1 Introduction

JMT Consulting has been commissioned by Atlassian (the Applicant) to prepare this document in response to the issues raised in by government agencies, community organisation groups and the public during the public exhibition of the proposed Atlassian Central State Significant Development (**SSD**) application (SSD-10405) in relation to the site at 8-10 Lee Street, Haymarket.

This document has been prepared to respond to the transport related issues raised by Transport for NSW and City of Sydney Council as reproduced on the following pages.

Drawing No
SKT25

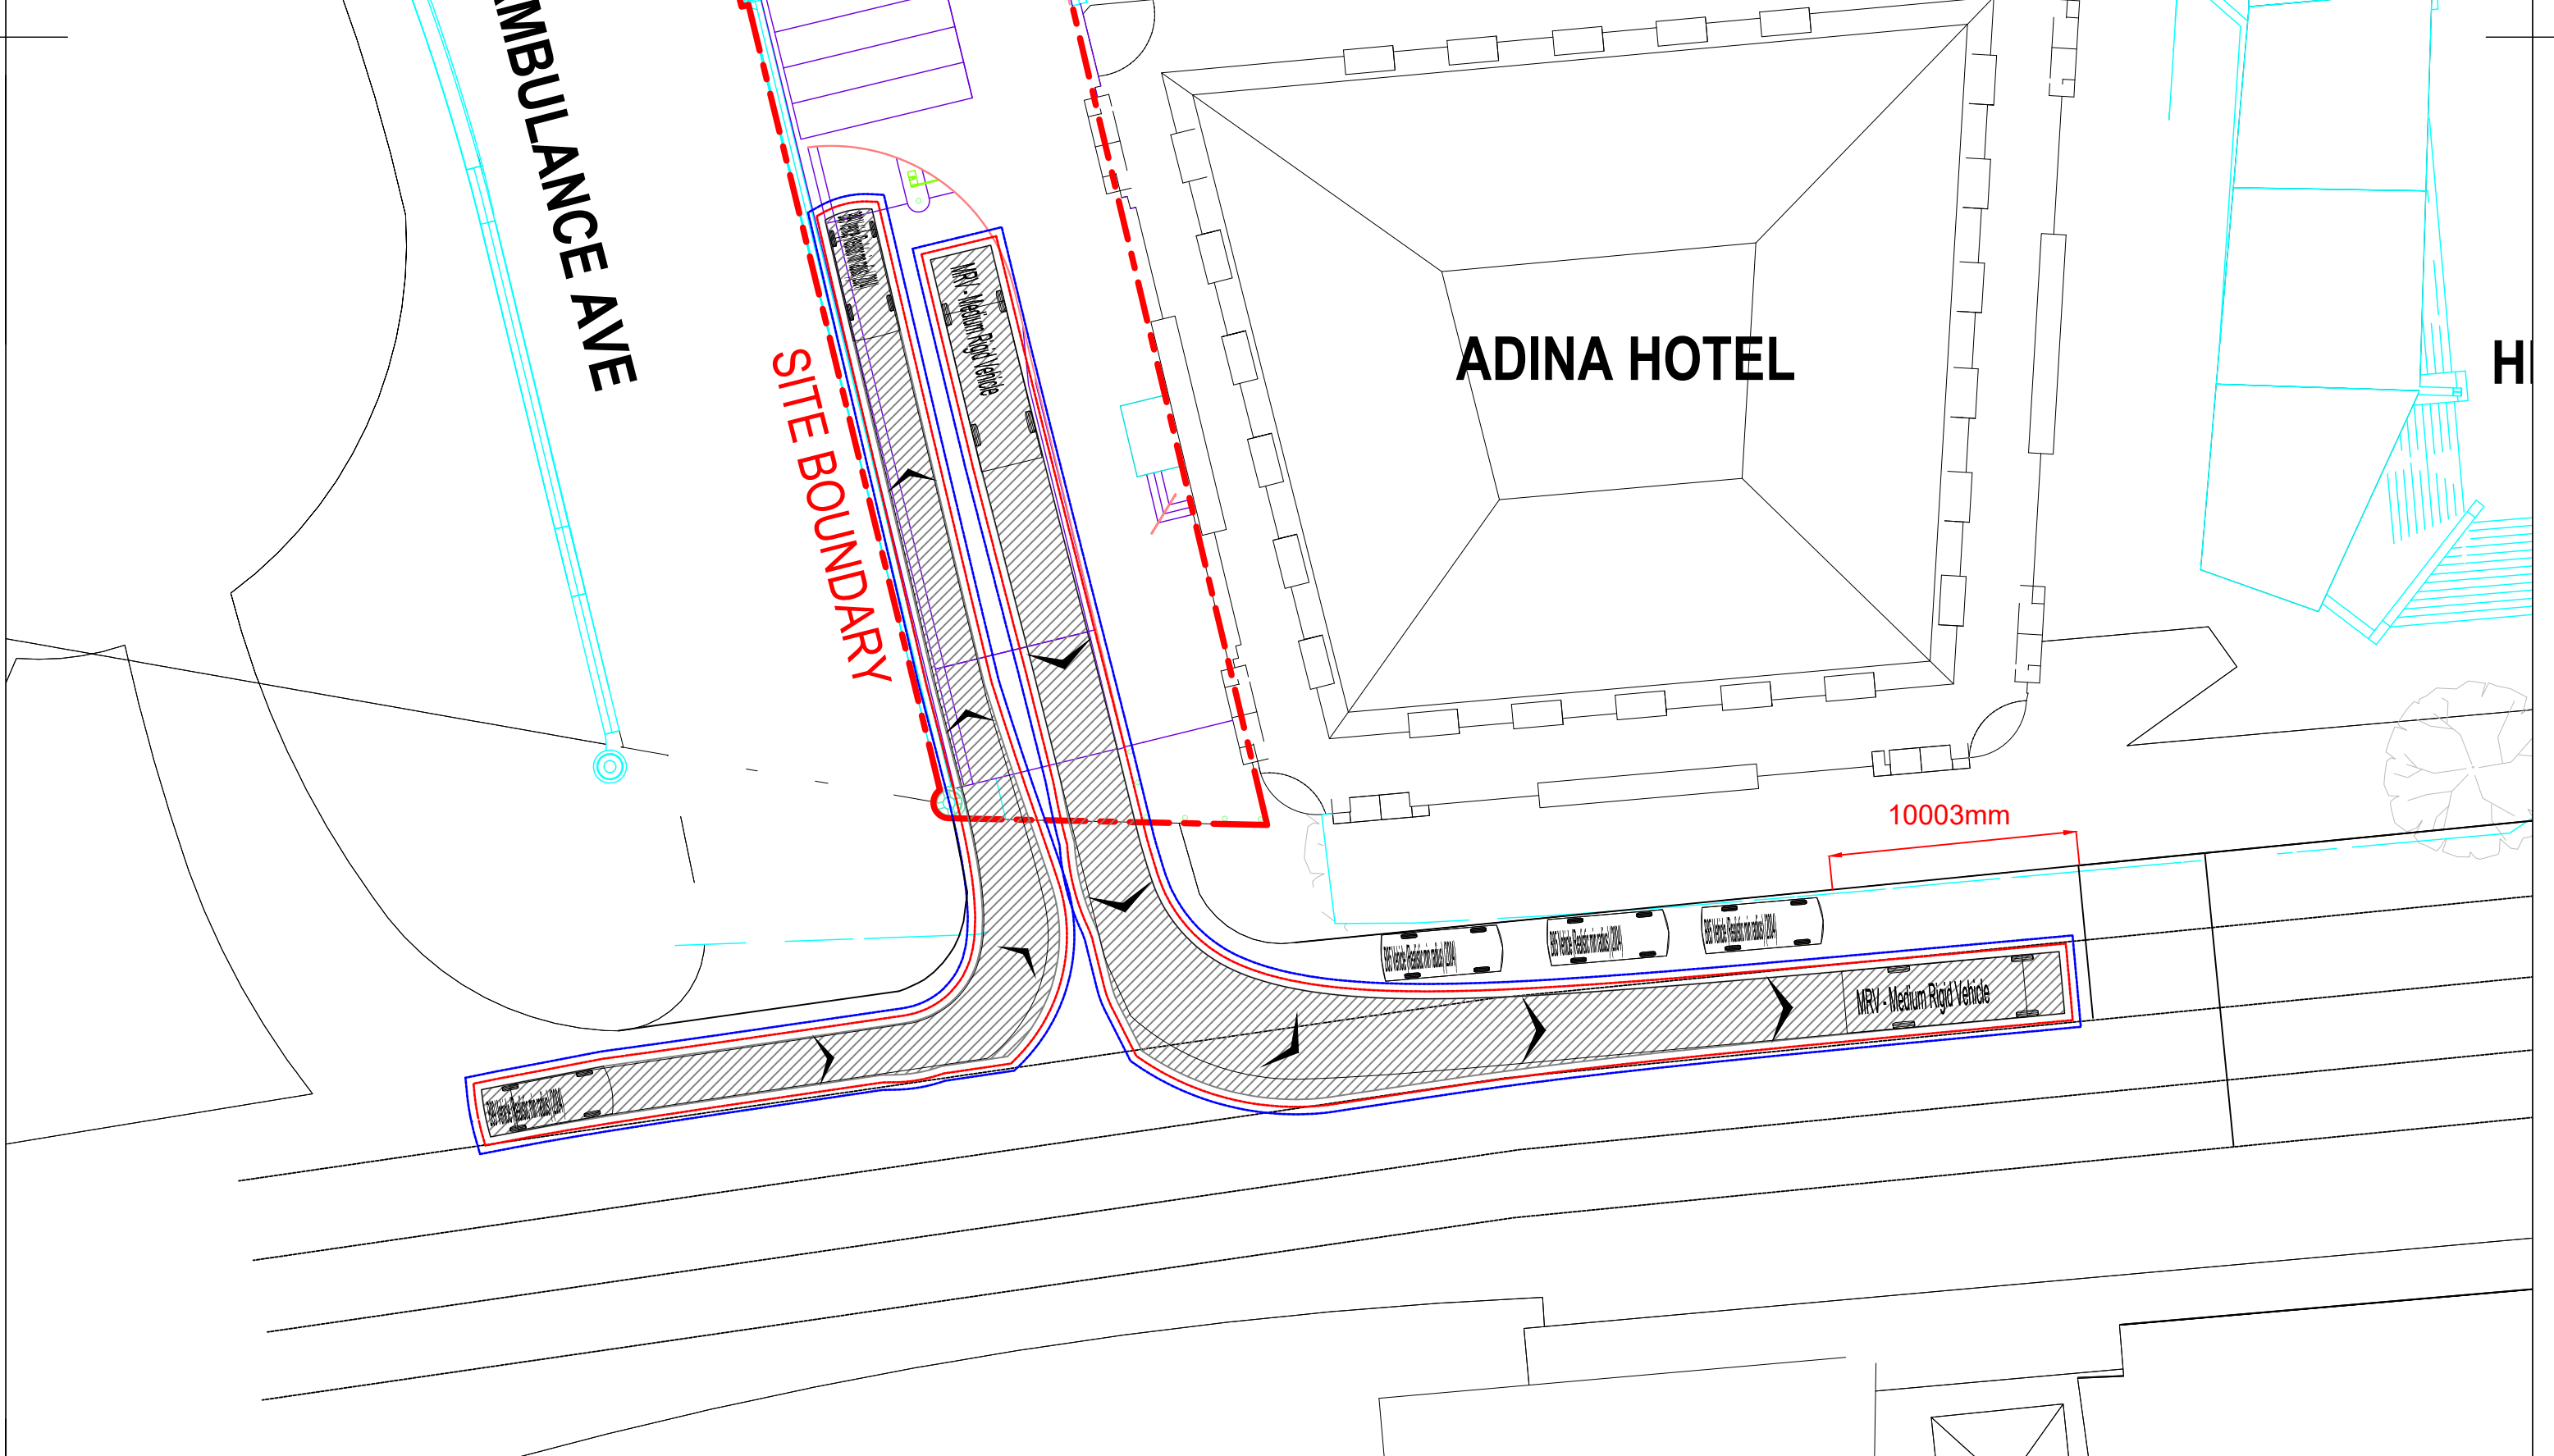
Transport for NSW Submission	JMT Consulting Response
Austroads Guide to Road Safety Part 6: Managing Road Safety Audits and Austroads Guide to Road Safety Part 6A: Implementing Road Safety Audits by an independent TfNSW accredited road safety auditor; and A Swept Path analysis for the simultaneous service vehicle movements to/from Lee Street through dive ramp structure for the maximum size of the vehicle that would expect to use the loading dock. Swept paths need to cover the vehicle travel paths between Lee Street and the loading dock. Based on the results of the road safety audit and the swept path analysis, the design drawings need to be reviewed to identify safety measures that may need to be implemented in consultation with TfNSW.	great detail the Lee Street driveway design and layout. Importantly it has been demonstrated through the additional swept path analysis that vehicles are safely able to enter and exit the site. The Lee Street driveway design will be further developed during the detailed design phase of the project well before construction commences. Therefore this point in the project will present a more suitable time to undertake the RSA in accordance with the TfNSW recommendation, with the findings and recommendations of the RSA to be incorporated in the final drawing set for the project. This requirement to undertake a RSA prior to the commencement of construction may be reinforced through a suitably worded condition of consent. At this stage it has been demonstrated however that the current driveway design provides for suitable width to accommodate simultaneous vehicle entry and exits to the site without impacting the flow of traffic on Lee Street. The dive ramp has been designed to provide for a 1:20 gradient at the top of the ramp so vehicles have excellent sight lines to oncoming pedestrians as they exit the site. The level of vehicle movements into the site is low at less than 1 vehicle every 4 minutes and this volume of traffic, coupled with the driveway design, will not impact pedestrian safety. The existing pedestrian refuge adjacent to Ambulance Avenue would be removed in conjunction with the closure of Ambulance Avenue to vehicle traffic. A continuous footpath treatment will be provided on the northern side of Lee Street to emphasise pedestrian priority at this location.

Record of all recorded crashes near the Lee Street / Ambulance Avenue intersection between 2015 and 2019

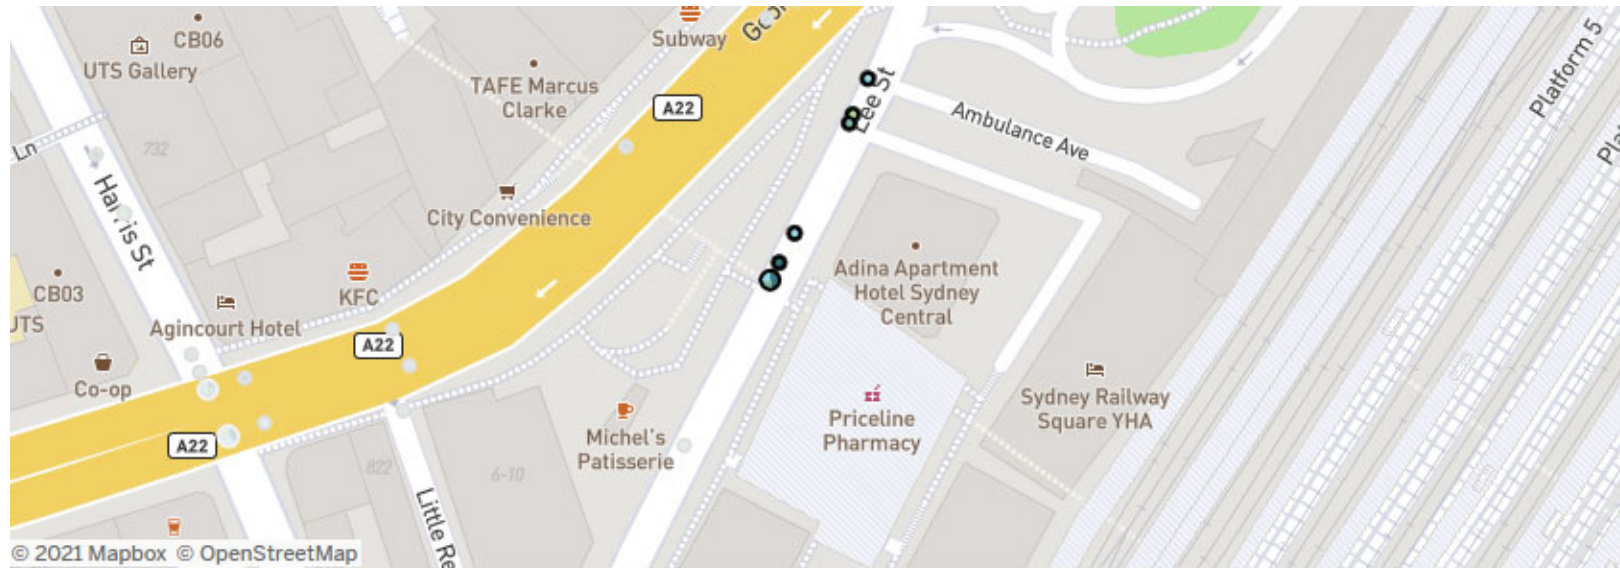
Transport for NSW Submission	JMT Consulting Response
The following comments are provided in relation to traffic and safety issues associated with Lee Street: The proposed development proposes changes to traffic arrangements along Lee Street. It is noted that no traffic and pedestrian safety analysis for Lee Street has been undertaken for the existing situation to confirm that the proposed measures would not exacerbate existing safety issues; The management of conflicts on the B2 ramp has been detailed in Section 4.5 of the Traffic Report, however, no arrangements are proposed to manage conflicts beyond this point at the Lee Street access. That is, a service vehicle about to depart onto Lee Street would prevent a vehicle entering given the driveway width of 5.5 m does not allow simultaneous movement. Importantly, this has the potential to impact the nearby Lee Street / Pitt Street / George Street intersection; The proposed pick up and drop off arrangement on Lee Street would have potential impact on general traffic and bus movements due to the following: The traffic and pedestrian conflict is a concern due to the number of near misses observed along Lee Street and the fact that a significant number of pedestrians cross at midblock locations along Lee Street. The proposed arrangement is likely to increase conflict involving vehicles leaving the kerb and vehicles changing lanes just after the intersection and pedestrians crossing Lee Street at midblock locations. Any incidents on Lee Street would have potential to impact on general traffic and bus operation with the CBD and beyond; and Introduction of a 'No Parking' zone on Lee Street immediately adjacent to the Adina Hotel would have the potential to impact on the operation of the road network including the operation of the nearby Lee Street / Pitt Street / George Street intersection. Based on the Traffic Report, the maximum queue length at	points combined accommodate over 50 parking spaces as well as a public drop off area for the Adina Hotel. Under the Atlassian proposal one of these vehicle access points will be removed (Ambulance Avenue) while the other (Upper Carriage Lane) will be converted from a public drop off area to a dive ramp servicing the Atlassian loading dock and Adina Hotel. Therefore the proposal results in an improved safety outcome by reducing the number of pedestrian/vehicle conflict points on Lee Street from two down to one. Further, the removal of existing parking spaces on Ambulance Avenue and Upper Carriage Lane will result in reduced traffic movements across the Lee Street footpath, even with the introduction of the dive ramp to the Atlassian loading dock. A review of crash data on Lee Street near Ambulance Avenue has been undertaken indicates there has only been three crashes in the last five years, none of which resulted in a serious injury or a fatality (see summary in Appendix B of this document). A number of pedestrian related crashes were recorded at the existing mid-block pedestrian crossing which will be unchanged as part of the proposal. The 'No Parking' zone on Lee Street would terminate 10m before the commencement of the crossing, consistent with TfNSW safety standards. Provision of this No Parking zone is considered to improve pedestrian safety when compared to current conditions, given southbound vehicles will no longer be travelling at high speeds in the kerbside lane. To emphasise pedestrian priority along Lee Street, the driveway entrance is to be fully integrated with the adjoining footpath, at one continuous level. The treatment will therefore be an area which is designed for pedestrians, across which vehicles can pass slowly. Drivers of vehicles will be guided and encouraged to give way to pedestrians on the footpath as required by
